## ADDENDUM #4

Date: April 24, 2025

Project: Tierney Park Improvements Project

Owner: Village of Lexington, Michigan

SHEET NUMBER:  
**SM-5.03**

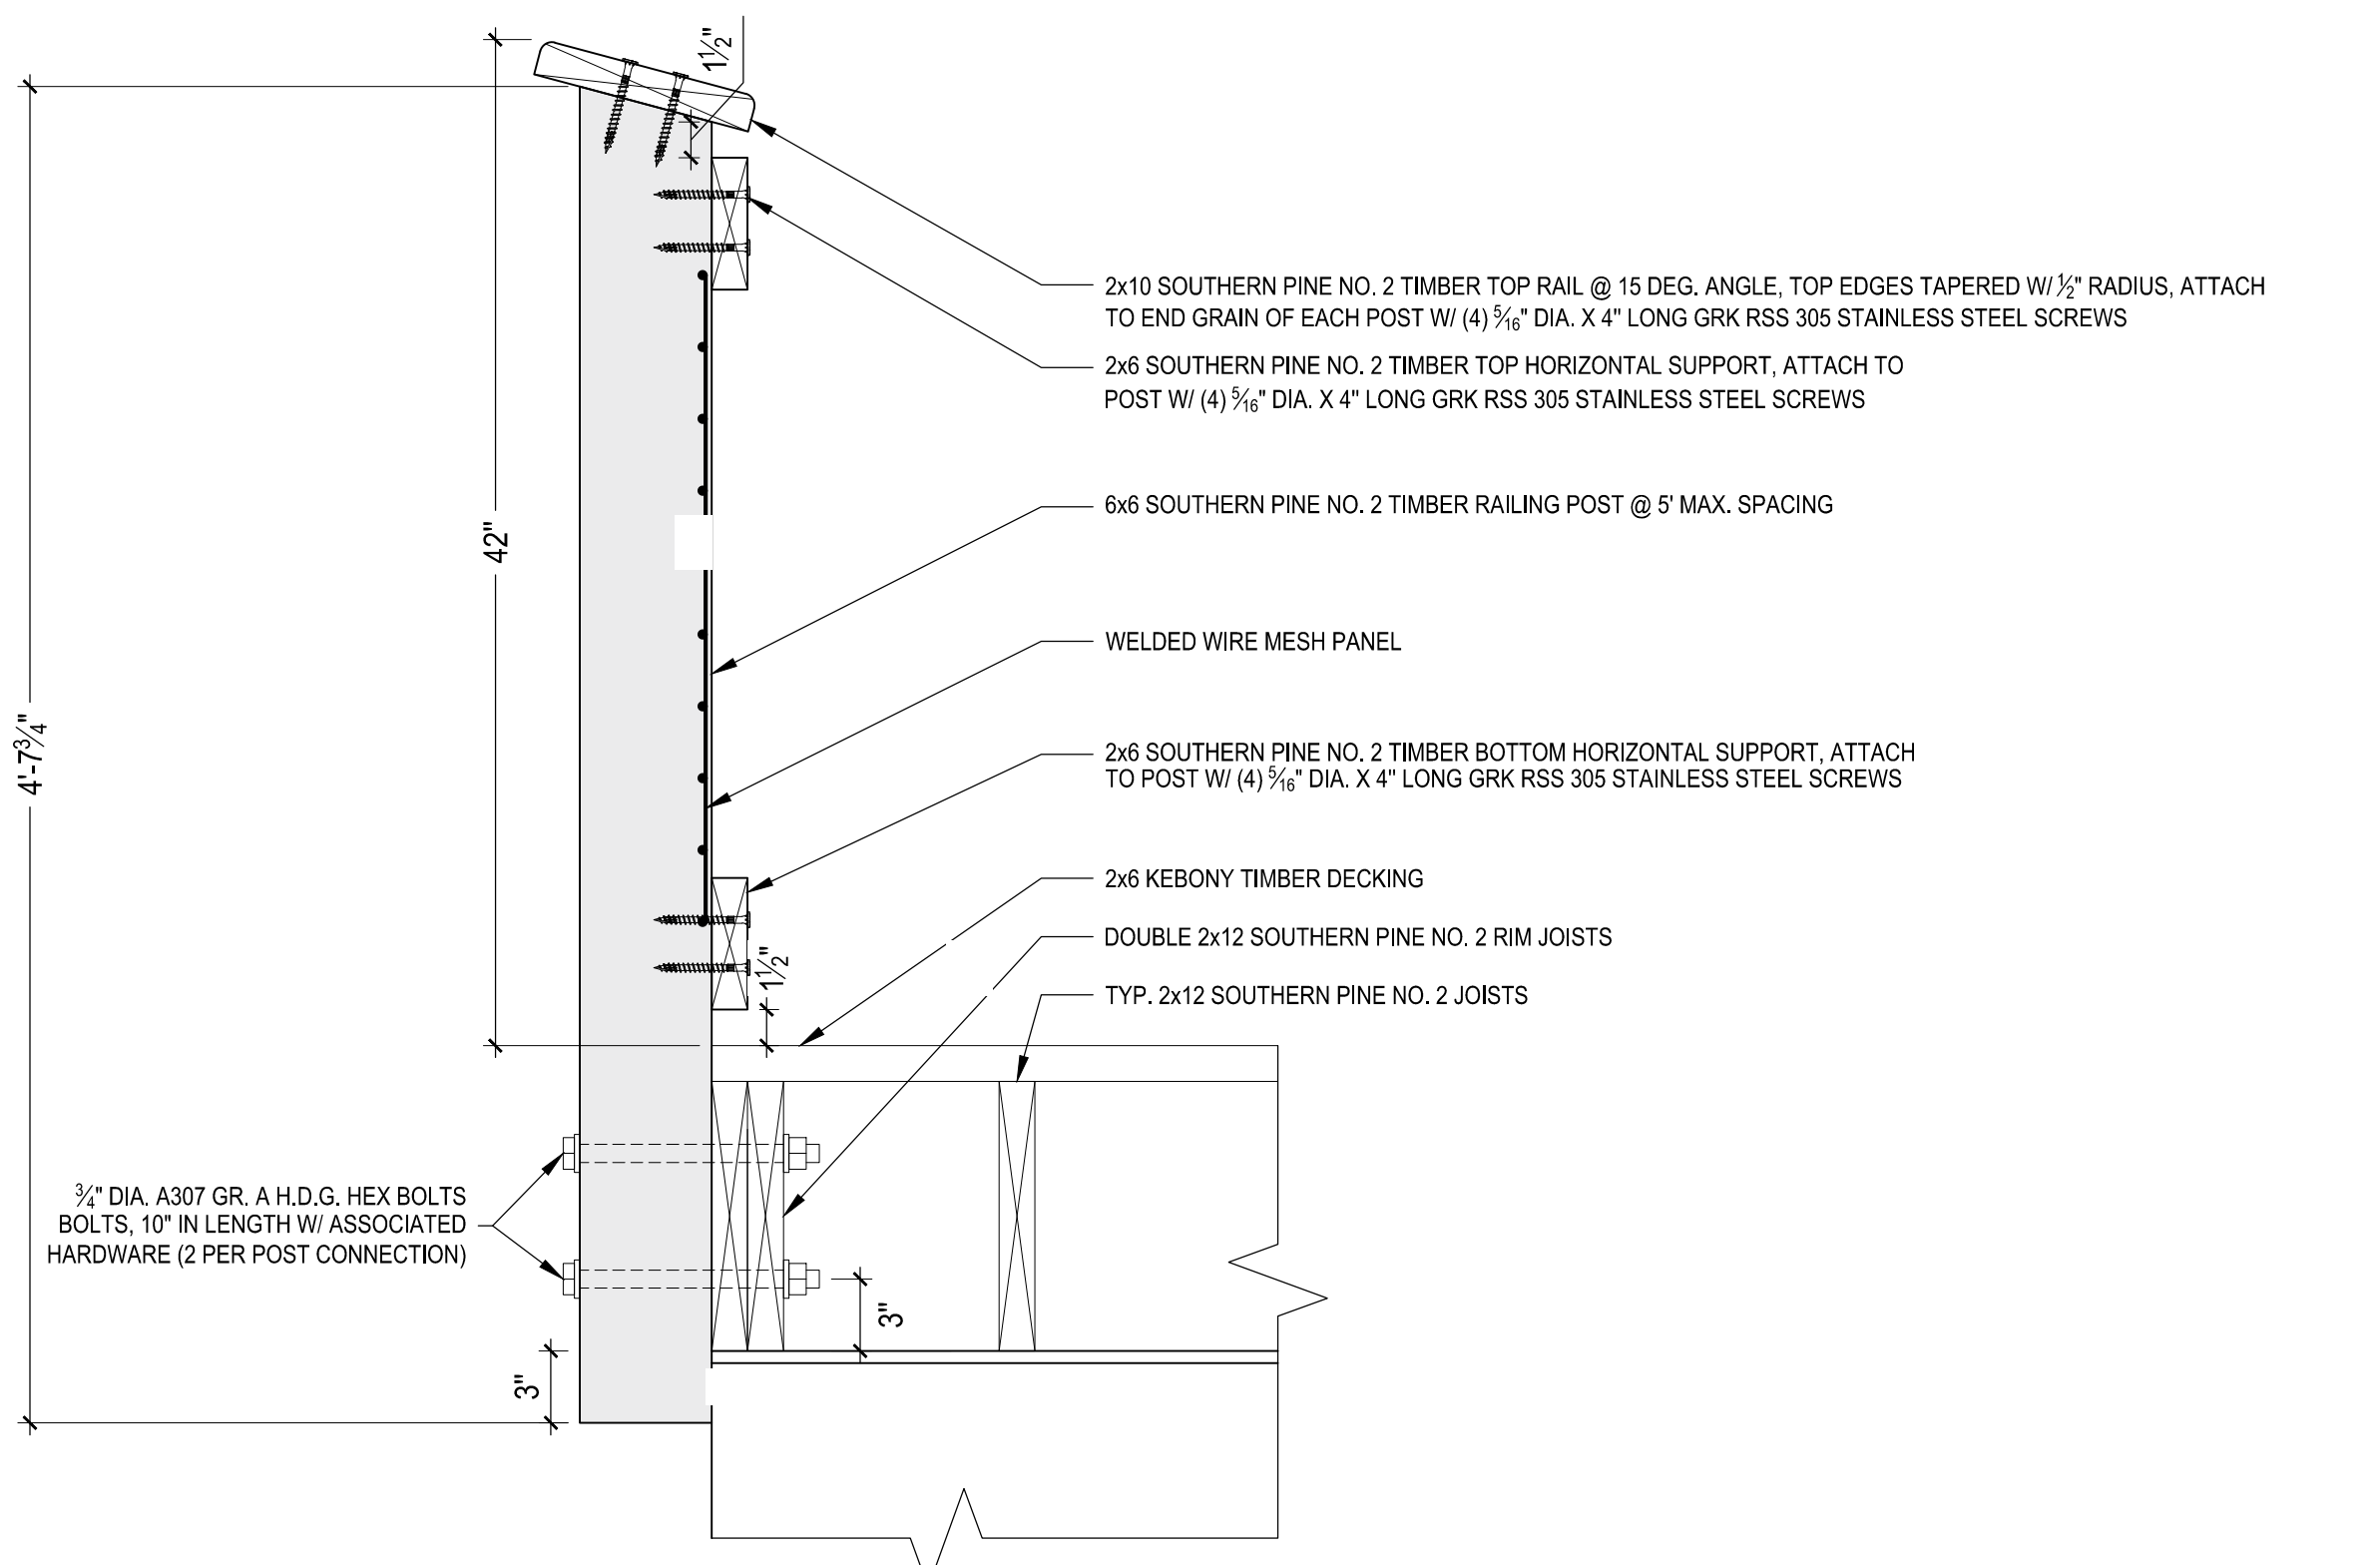
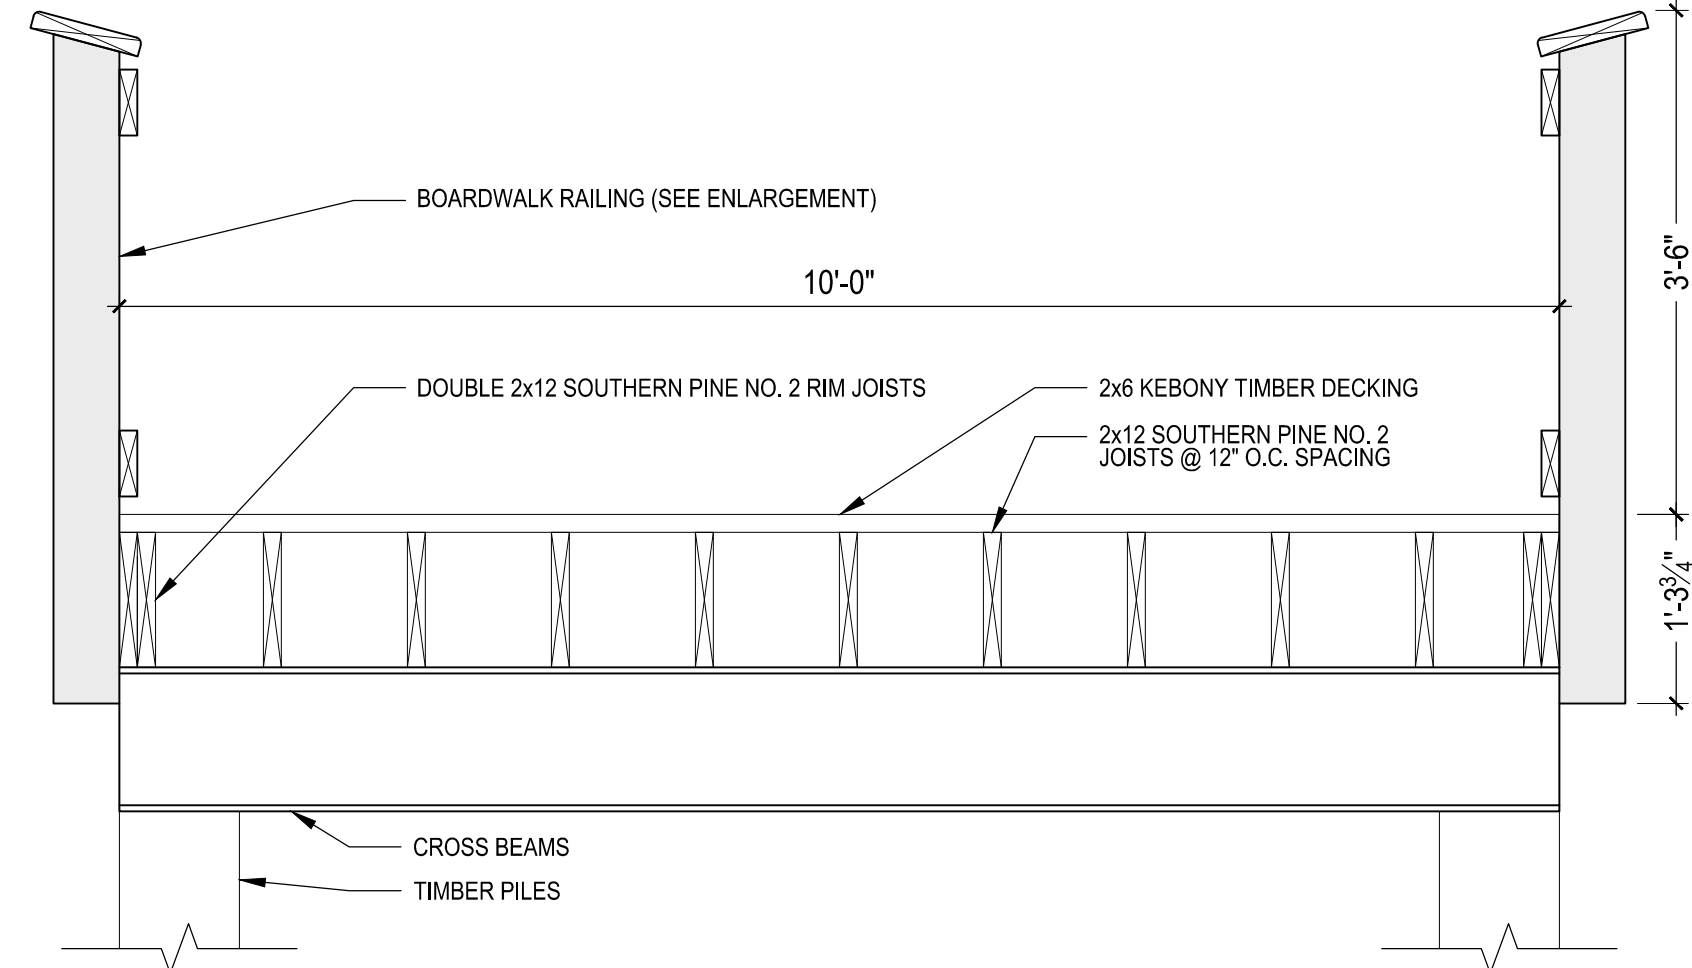
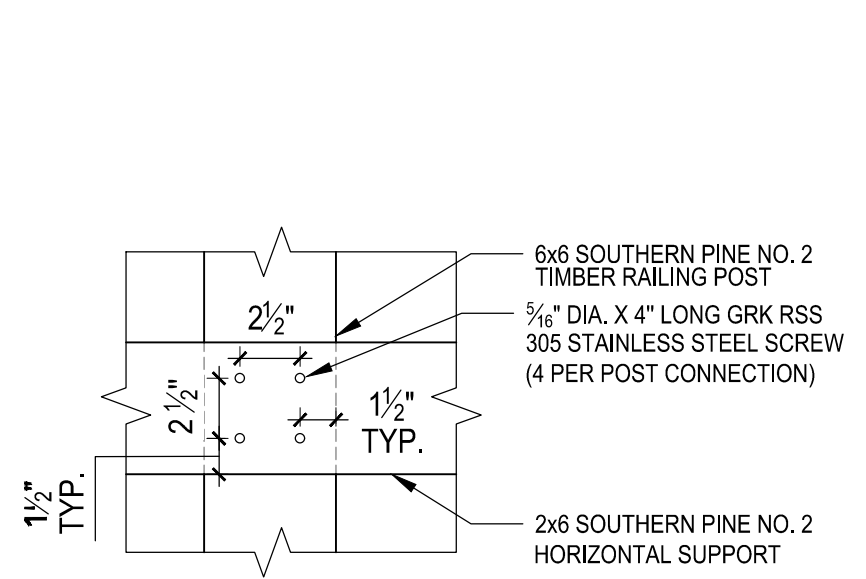
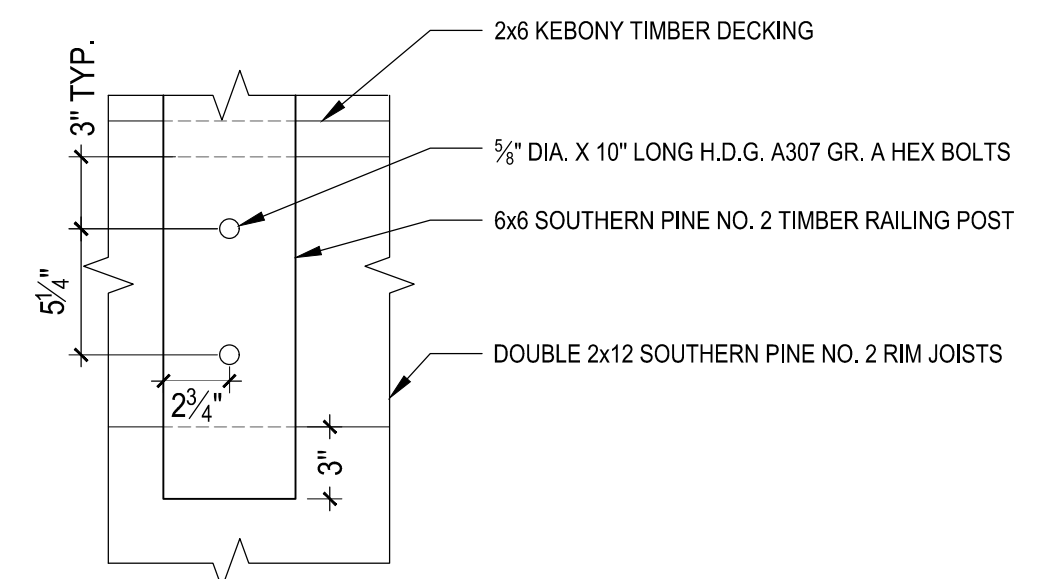
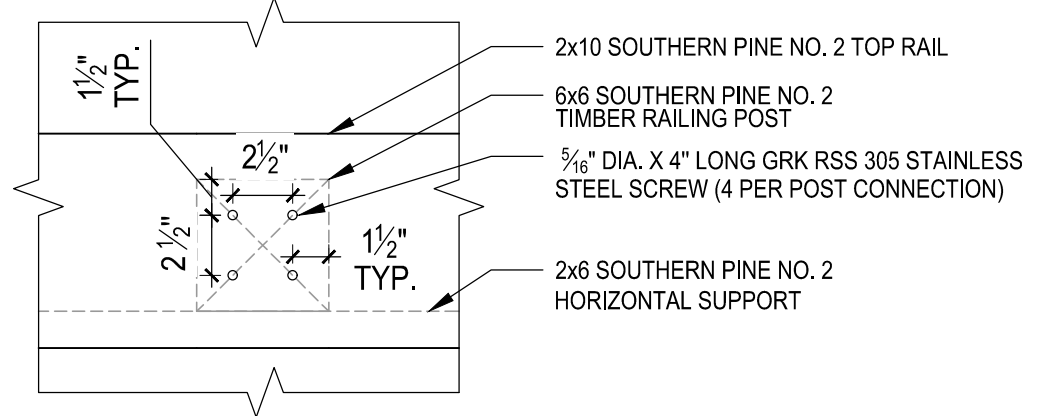
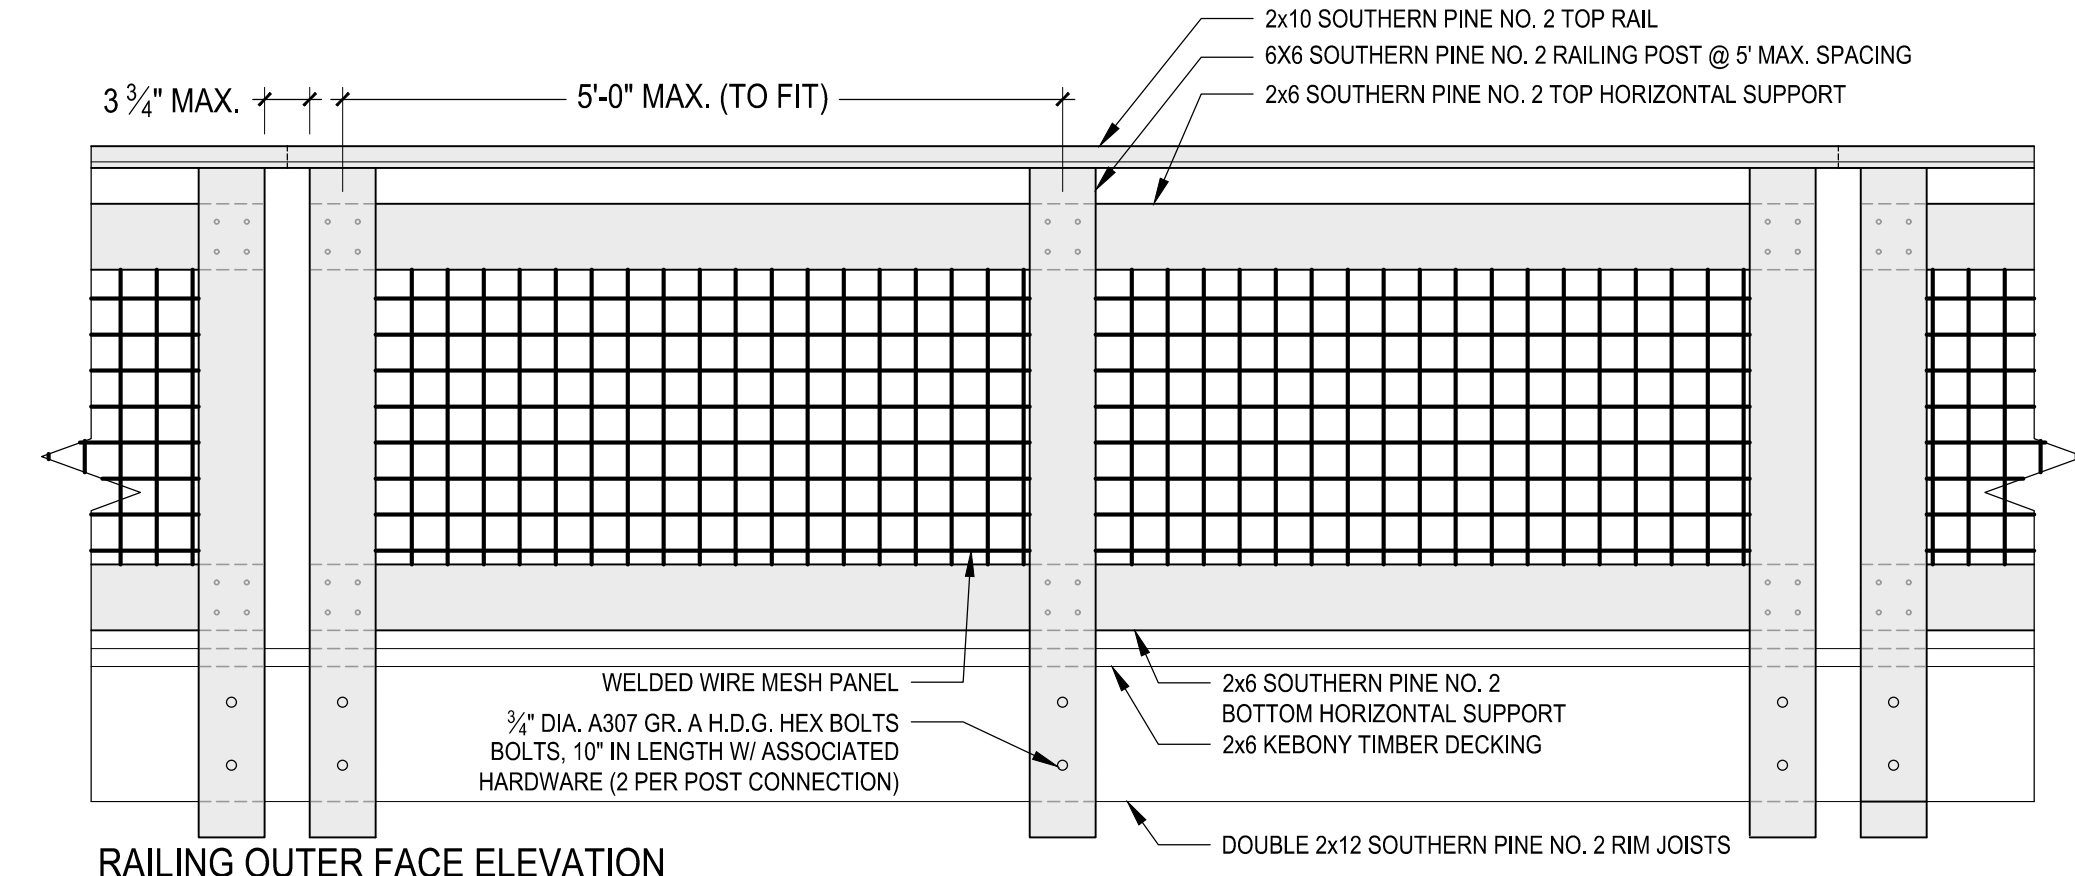
1. **SM-5.03** Structural Marine Details
  - a. Boardwalk Railing details have been updated.
